U. S. NUCLEAR REGULATORY COMMISSION  
REGION B

Meeting Between NRC and Intervenors Regarding Midland

(8/11/83)

FIGURE 1-1

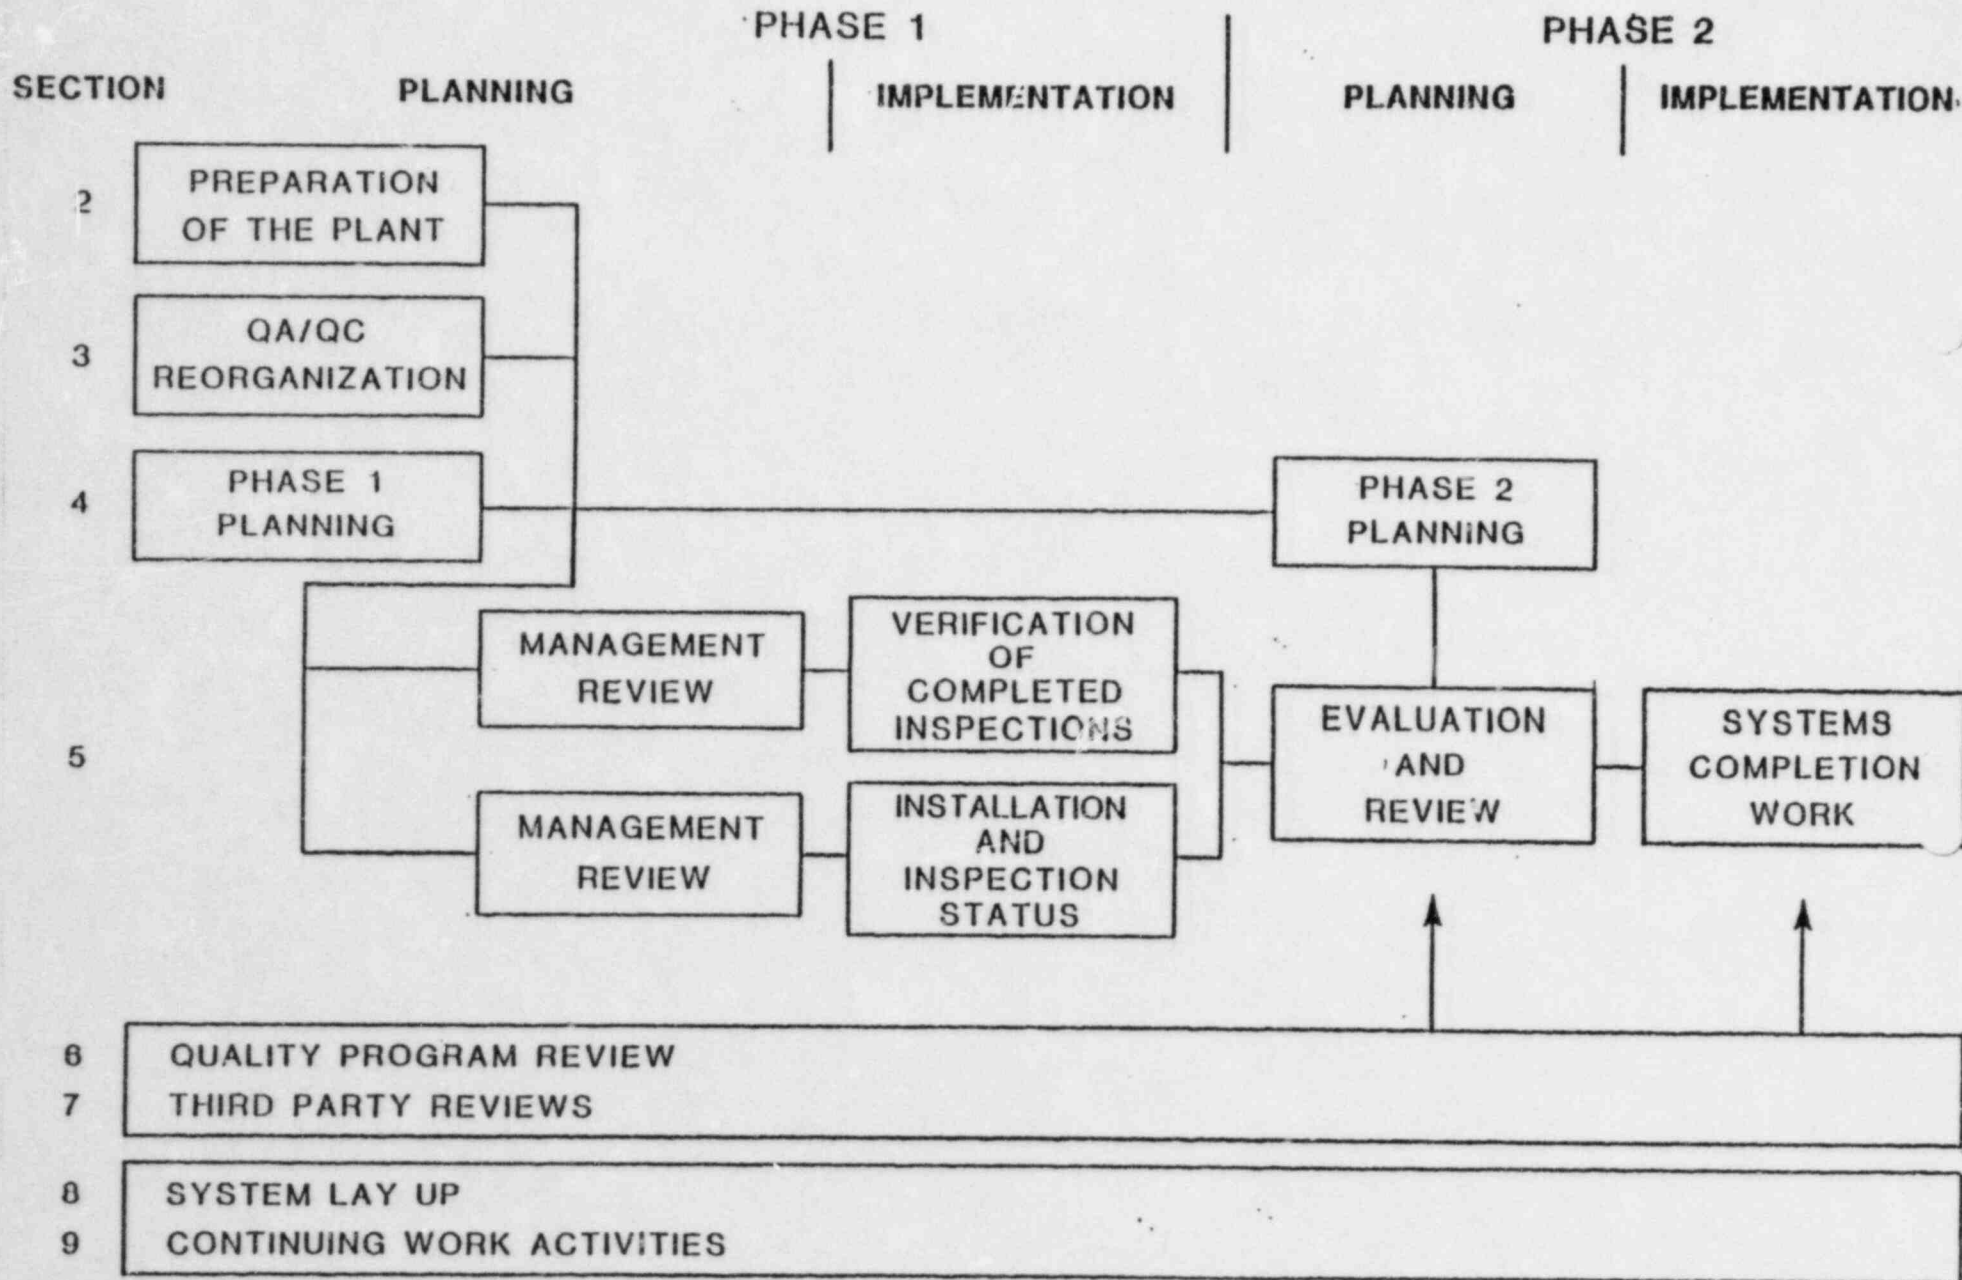
7. Figure 1-1

6. Figure 1-1
